Product Change Notice

PCN#: EE-PCN21013
07/01/2021

BK-1A5601 and BK-1A5601-01

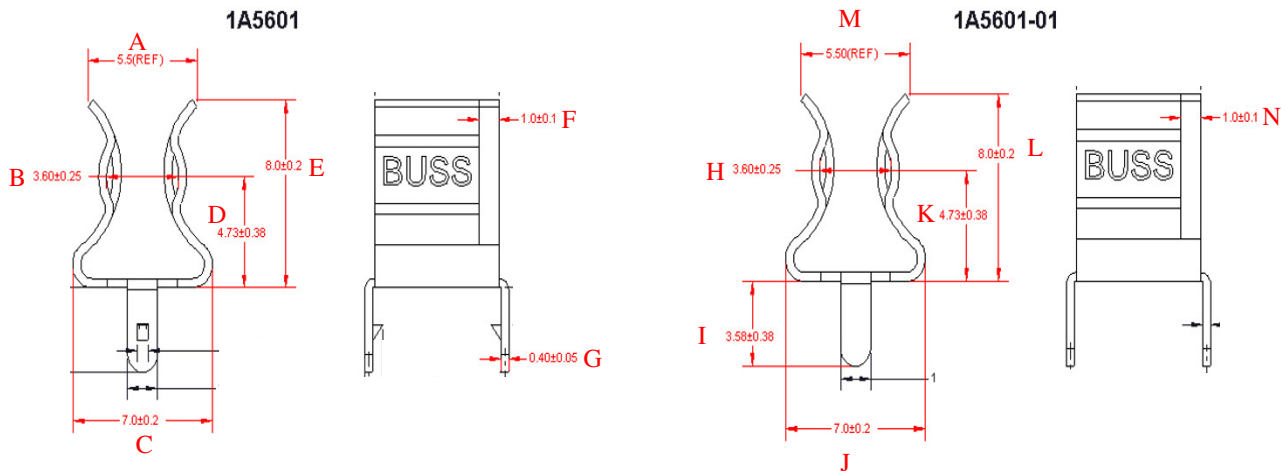
The 1A5601 and 1A5601-01 manufacturing country of origin will change to Taiwan.

The 1A5601 and 1A5601-01 will offer the same circuit board pad layout. There will be no effect on the quality, reliability, or performance. Dimensions of the Taiwan produced fuse clips will be updated as below. There are no other changes to fit, form or function of the fuse clip.

A Before: 6.25 mm
A After: 5.5 mm

B Before: 4.20 ± 0.2 mm
B After: 3.60 ± 0.25 mm

C Before: 6.76 mm
C After: 7.0 ± 0.2 mm

D Before: 5.56 ± 0.38 mm
D After: 4.73 ± 0.38 mm

E Before: 8.73 ± 0.38 mm
E After: 8.0 ± 0.2 mm

F Before: 1.0 ± 0.1 mm
F After: 1.0 ± 0.1 mm

G Before: 0.50 ± 0.05 mm
G After: 0.40 ± 0.05 mm

H Before: 4.20 ± 0.2 mm
H After: 3.60 ± 0.25 mm

I Before: 3.8 mm
I After: 3.58 ± 0.38 mm

J Before: 6.4 ± 0.2 mm
J After: 7.0 ± 0.2 mm

K Before: 5.56 ± 0.38 mm
K After: 4.73 ± 0.38 mm

L Before: 8.73 ± 0.38 mm
L After: 8.0 ± 0.2 mm

M Before: 6.3 mm
M After: 5.50 mm

N Before: 1.0 ± 0.1 mm
N After: 1.0 ± 0.1 mm
